DOE/EA-1050
May 1996

Environmental Assessment

Test Area North Pool Stabilization Project

**U. S. DEPARTMENT OF ENERGY
FINDING OF NO SIGNIFICANT IMPACT FOR THE
TEST AREA NORTH POOL STABILIZATION PROJECT
AT THE IDAHO NATIONAL ENGINEERING LABORATORY**

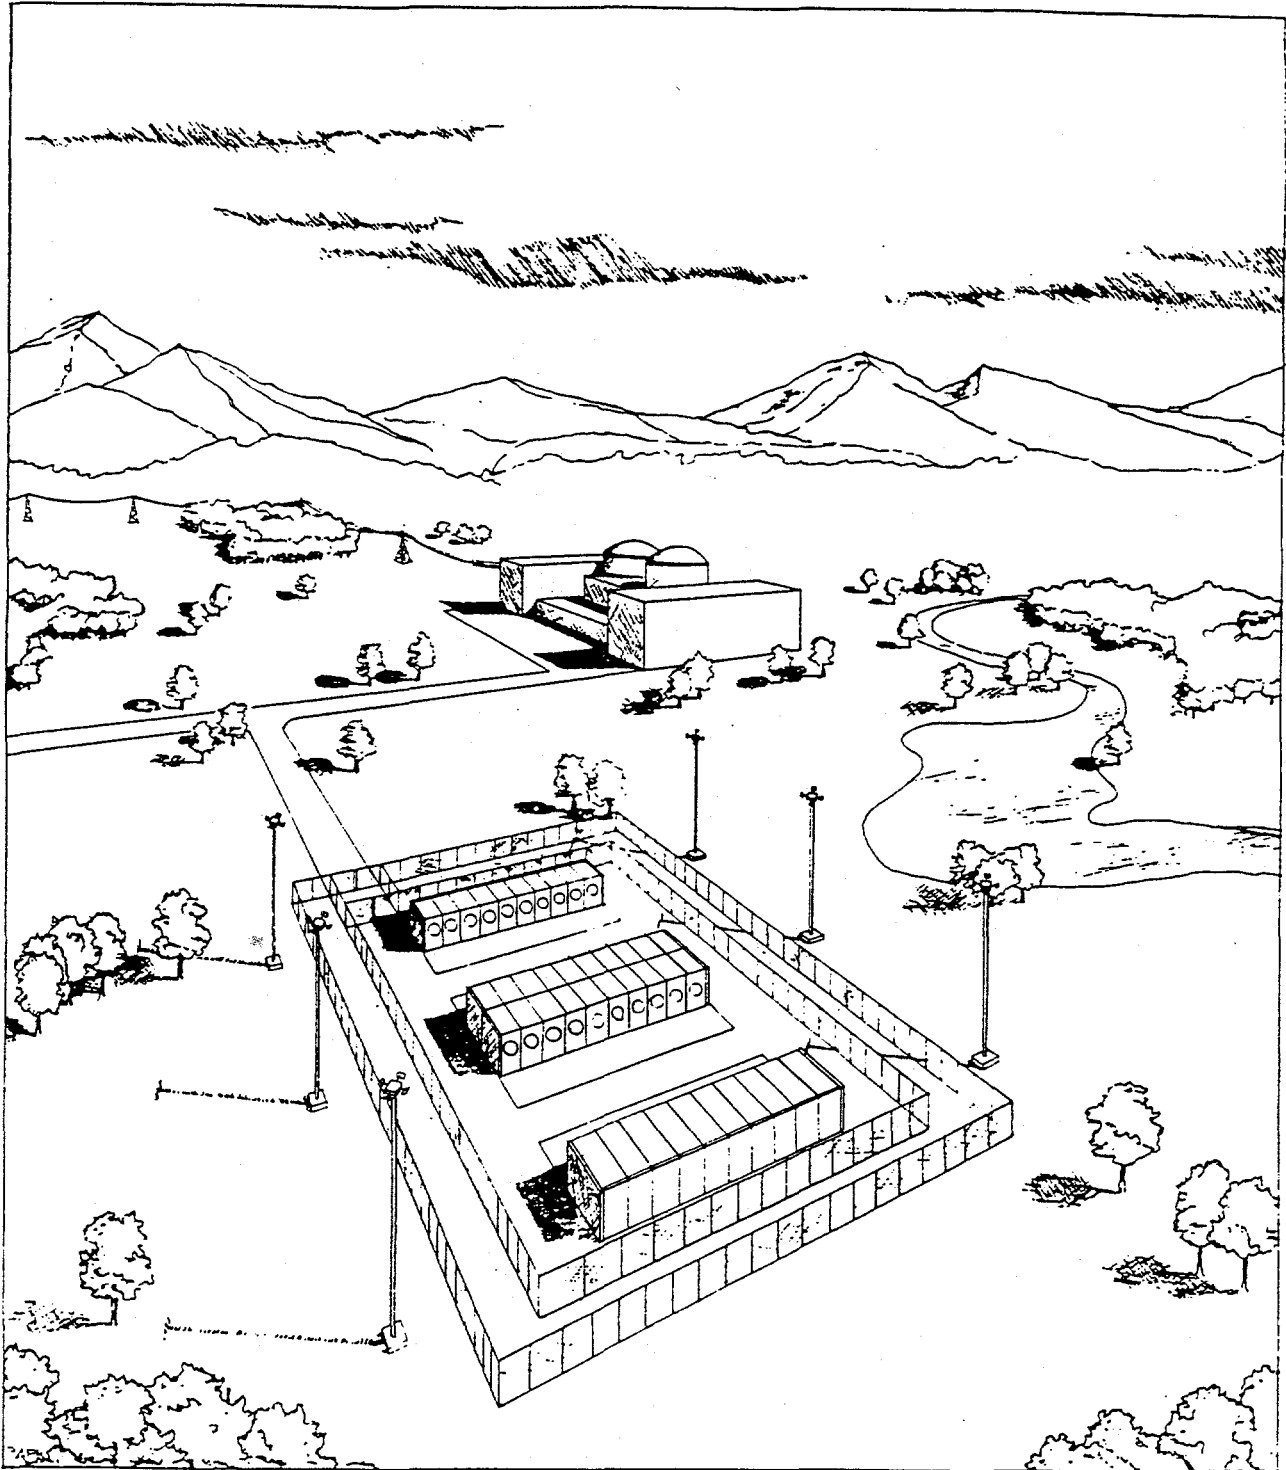
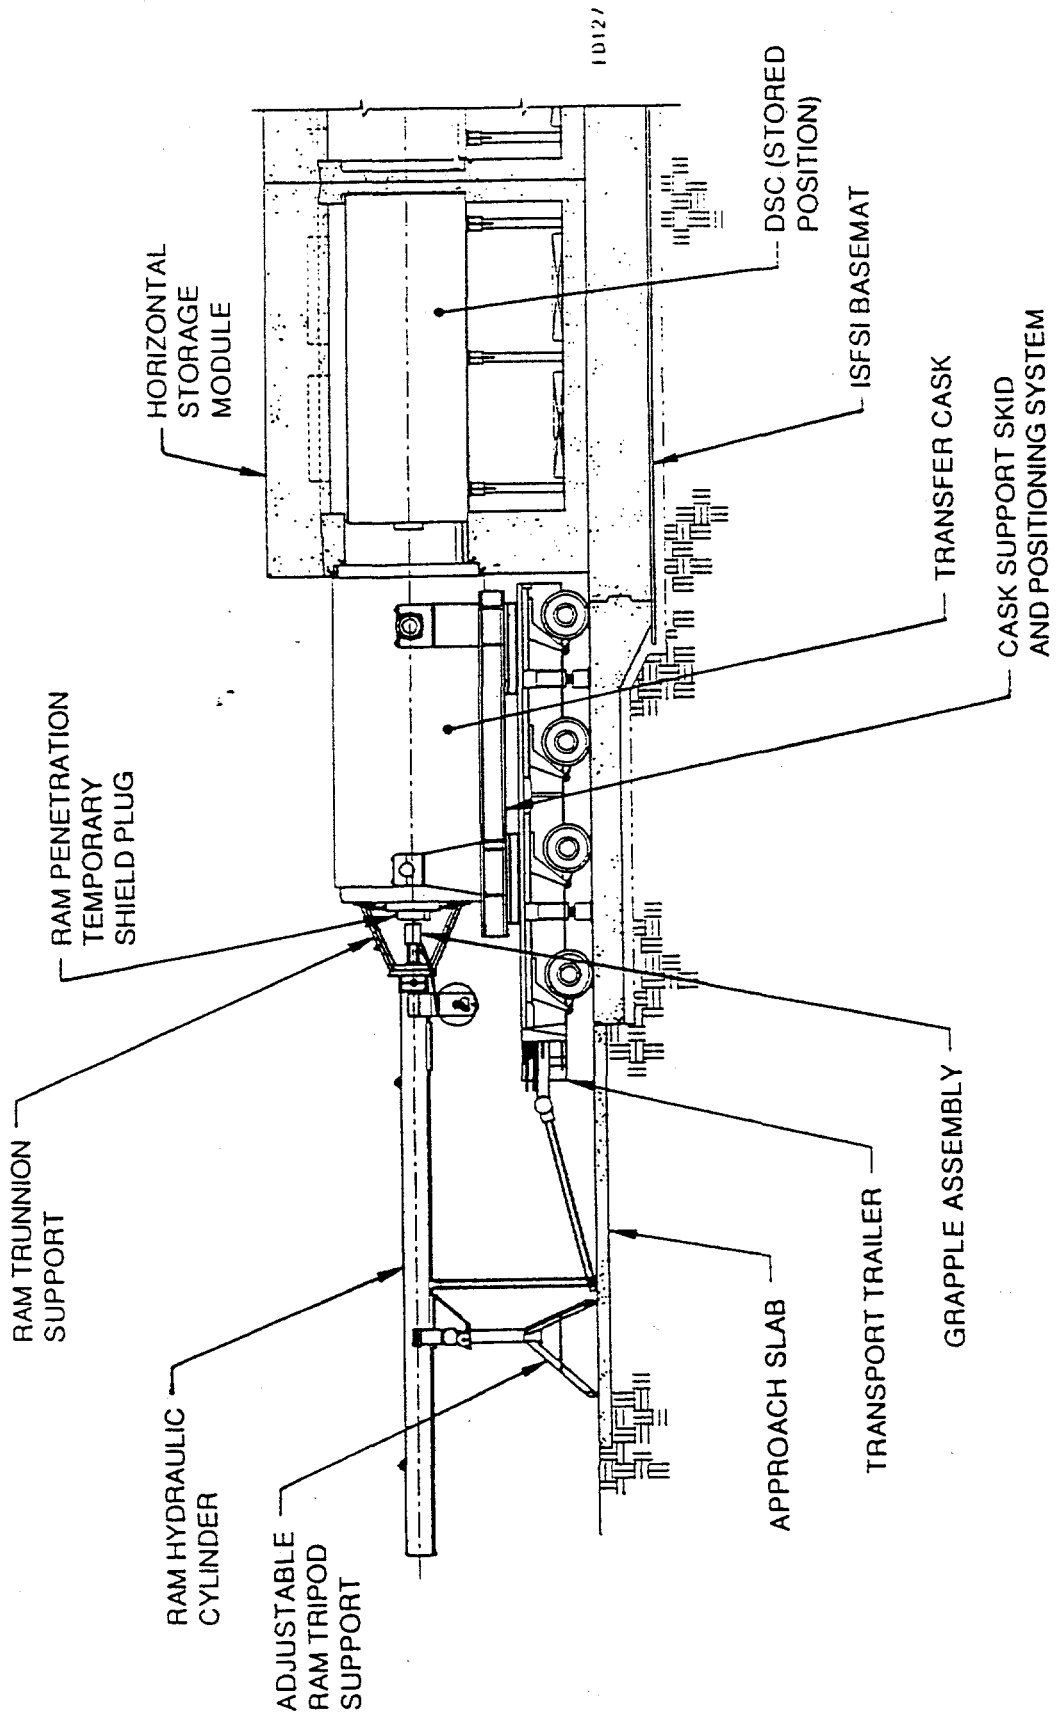
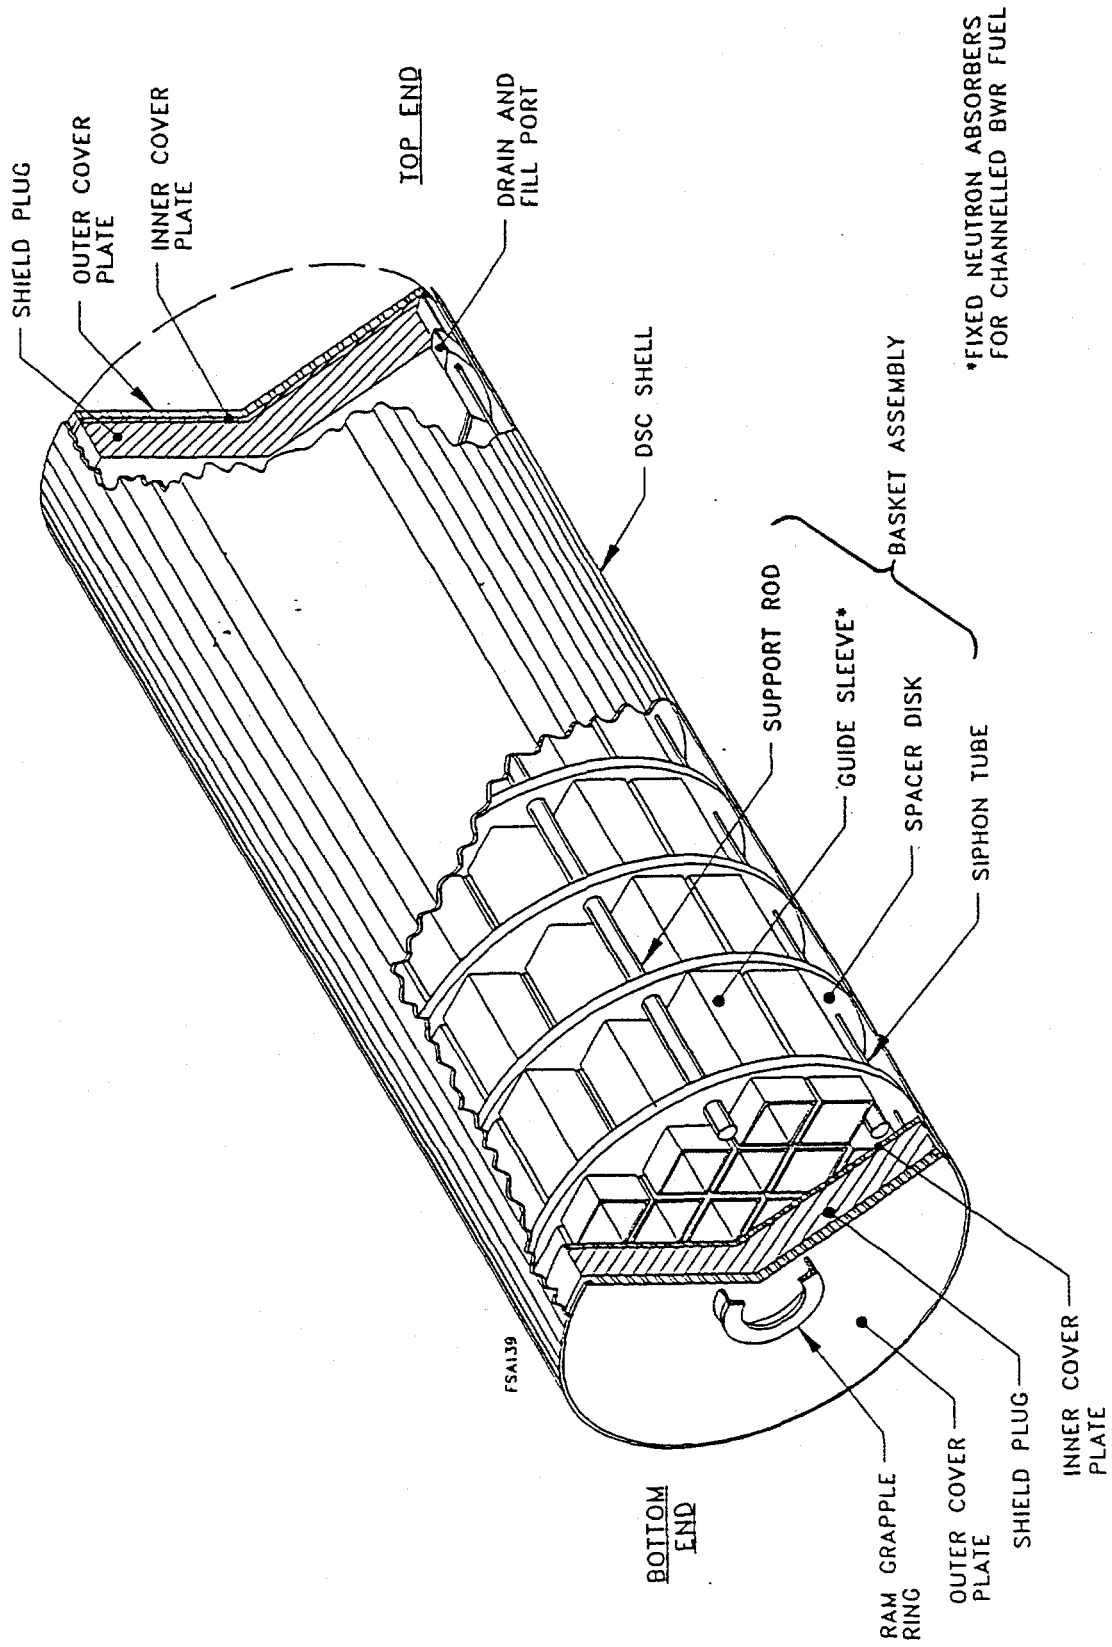
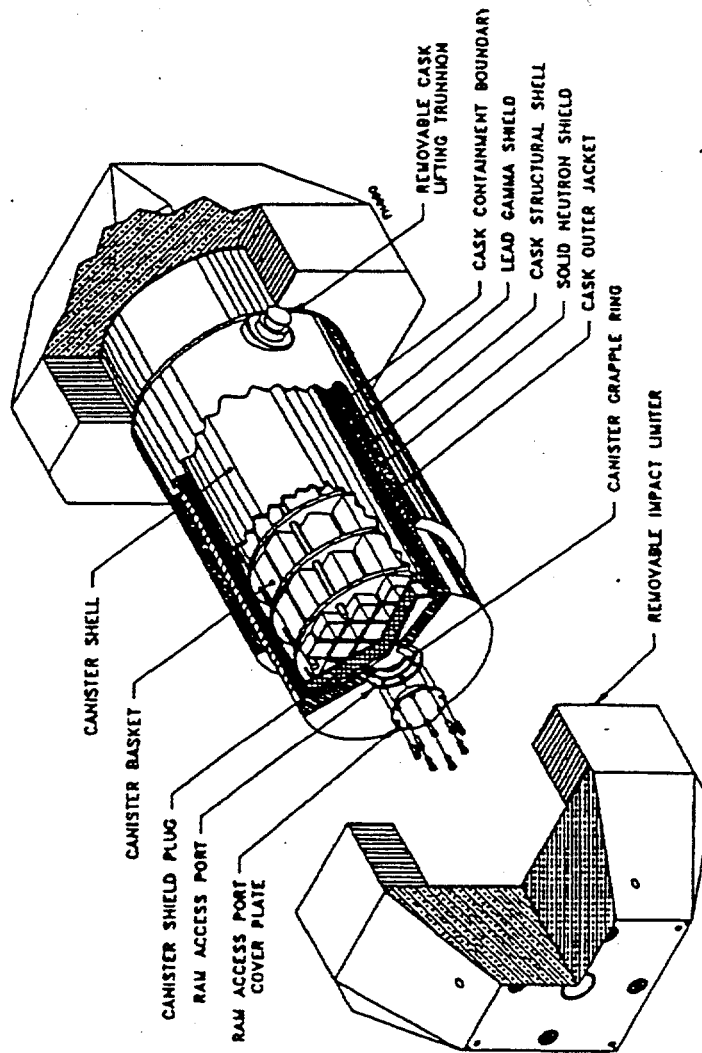
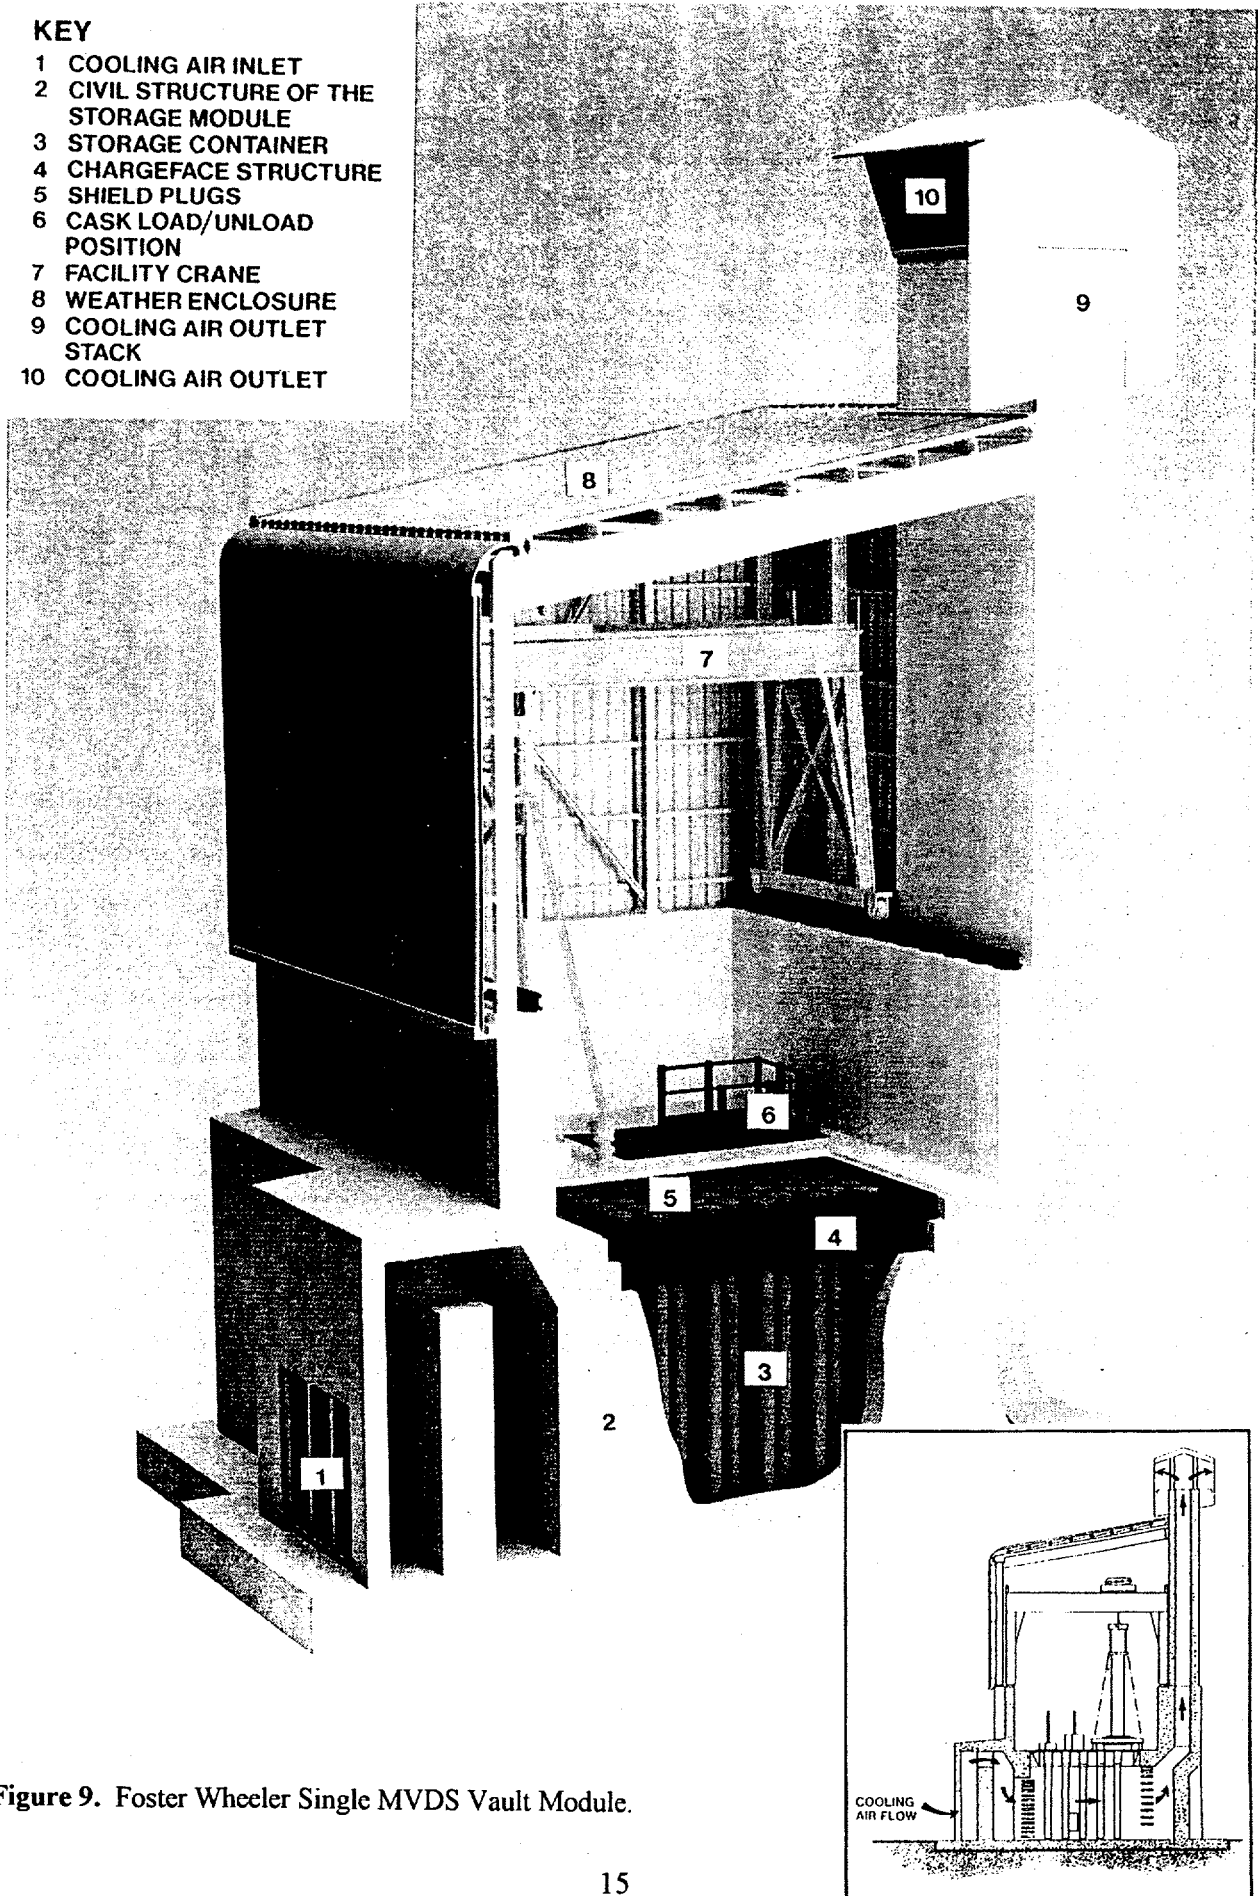
7. Comment: The statement is made that there are several types of ISS facilities available that could be modified to accommodate the TMI core debris and provides some description of them. DOE needs to provide more specific detail for the decisionmaker and the public to evaluate this issue.

Response: Figures 5 through 10 have been added to the EA to identify various existing commercial dry SNF storage systems that could be available. Any existing design would require modifications to accommodate the unique requirements of the TMI core debris. The extent of modifications required is not known at this time, since procurement of a storage system has not yet occurred. The environmental impacts of these different hypothetical designs do not differ from one design to the next.
